**Notice of Allowability**

10/791,575

LIANG, GEORGE

### EXAMINER'S AMENDMENT

***FIG. 1***

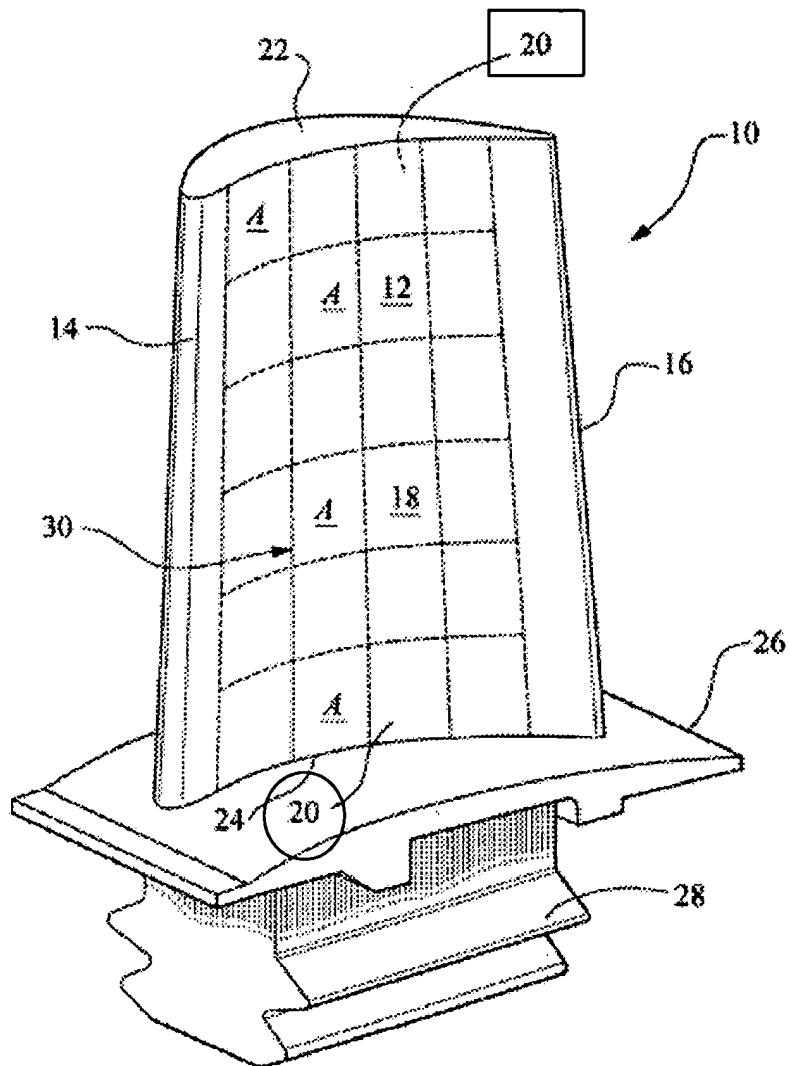
In Fig. 1 reproduced above, the numeral "20" shown in the box identifies the suction side, so the numeral "20" shown in the circle should be deleted.

FIG. 4A

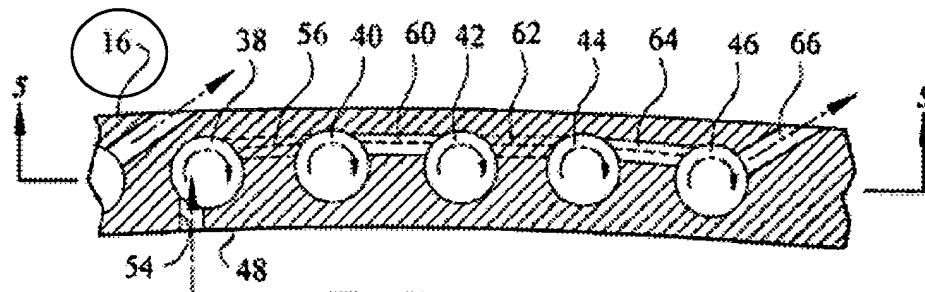
In Figs. 4A and 4B reproduced above, the numeral "16" (disclosed as a *trailing edge*) should be changed to "20" (disclosed as a *suction side*), commensurate with the disclosure.
